NACELLE - EXHAUST - THRUST REVERSER - HOLD-OPEN ROD AND FITTING - REPLACEMENT OF

MODEL APPLICATION
V2500-A1

V2500-NAC-78-0001

Replacement of Forward and Aft Hold Open Rods on Thrust Reverser Figure 1

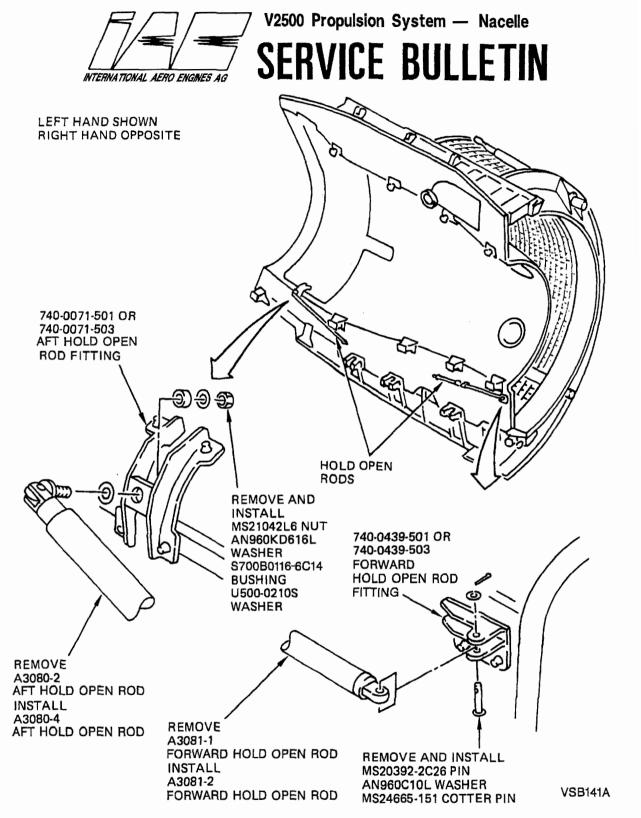
- B. Rework of Thrust Reverser with Kit V2578001-551.
  - (1) Replacement of forward and aft hold-open rods. (Refer to Figure 1).
    - (a) Remove cotter pin, washer, and pin which attaches the forward hold-open rod to the forward hold-open rod fitting. Keep the pin and washer, discard the cotter pin.

- Return the A3081-1 hold-open rod to the manufacturer. Refer to paragraph 3.E for address.
    - (b) Put A3081-2 forward hold-open rod on the forward hold-open rod fitting. Attach the rod to the fitting with MS20392-2C26 pin, AN960C10L washer, and MS24665-151 cotter pin.

- (c) Remove the nut, bushing, and washers which attach the aft hold-open rod to aft hold-open rod fitting. Keep the hardware. Return the A3080-2 hold-open rod to the manufacturer. Refer to Paragraph 3.E for address.

- (d) Put the A3080-4 aft hold-open rod on the aft hold-open rod fitting. Attach with U500-0210S washer, S700B0116-6C14 bushing, AN960KD616L washer, and MS21042L6 nut. Torque nut to 160-190 lb-in. (18.1-21.5 N.m).

Removal of Aft Hold Open Rod Clip Figure 2

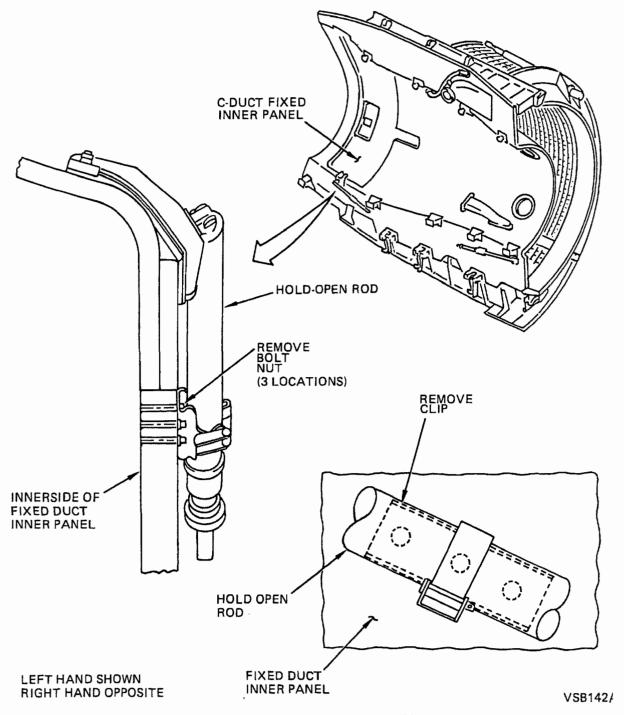
- (2) Relocation of aft hold open-rod clip. (Refer to figure 2).
  - (a) Find the aft hold open-rod clip assembly on the C-duct fixed inner panel.
  - (b) Remove three nuts and bolts which attach the clip to the panel. Remove clip, keep the clip and hardware.

- (c) Wipe clean the holes where the clip was attached to the panel. Use a clean cloth or swab wet with methyl isobutyl ketone (MiBK). Wipe clean before solvent dries.

Reinstallation of Aft Hold Open Rod Clip Figure 3

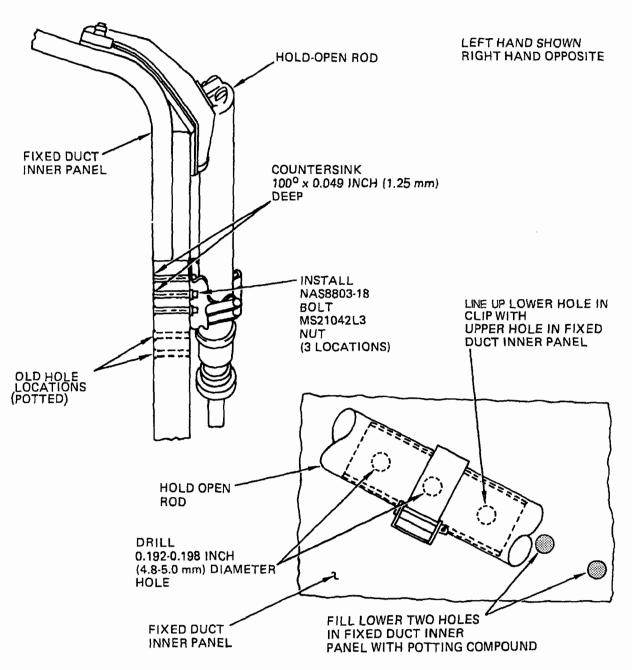
- (d) Mix Epocast H1843 potting compound and 9216 hardener in accordance with the manufacturer's instructions.
- (e) Fill the lower two of the holes in the panel where the clip was attached. Wipe off excess material before it dries. (Refer to Figure 3).

- (f) Cure the potting compound for three hours at 250°F (121°C) with heat lamps.
- (g) Line up the lower hole of the clip with the upper hole in the panel.

- (h) Attach the clip to the panel with NAS8803-18 bolt and MS21042L3 nut. Tighten the nut by hand.
- (i) Snap the hold-open rod into the clip.
- (j) Mark the location of the clip's two remaining holes on the panel.

- (k) Remove the clip, and drill the marked holes through with 0.192-0.198 inch (4.8-5.0 mm) diameter drill. Remove the burr from the holes.
- (i) Countersink the two holes on the outer side of the panel 100 degrees by 0.049 inch (1.25 mm) deep.

- (m) Remove the nut and bolt which attaches the clip to the panel.

Removal and Installation of Bracket Figure 4

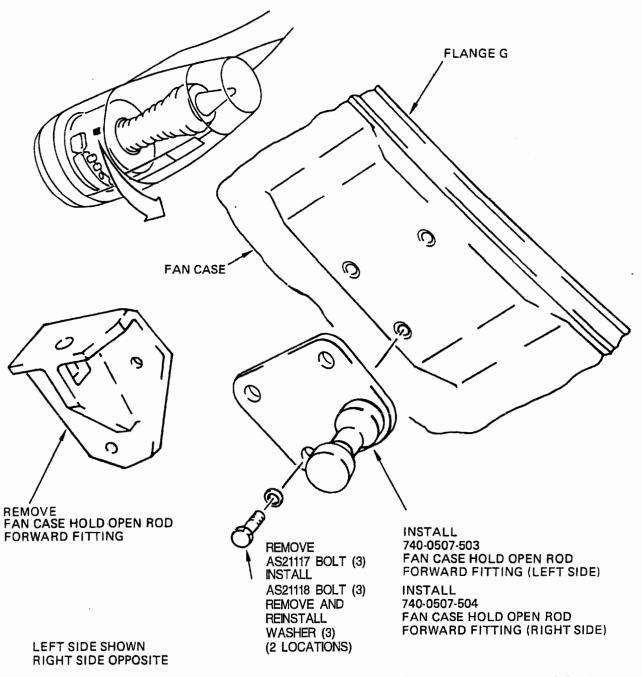
- (3) Rework of Fan Case with Kit V2578001-553 (Refer to Figure 4).
  - (a) Find the forward fan case hold open rod fittings forward of flange G on the fan case.
  - (b) Remove the bolts and washers which attach the fittings to the fan case. Keep the washers; discard the bolts and fittings.
  - (c) Put the 740-0507-503 fitting on the left side of the fan case and the 740-0507-504 fitting on the right side of the fan case.
  - (d) Attach the fittings to the fan case with three AS21118 bolts and the washers removed in step (b). Torque the bolts to 85-95 lb-in (9.6-10.7 N.m).
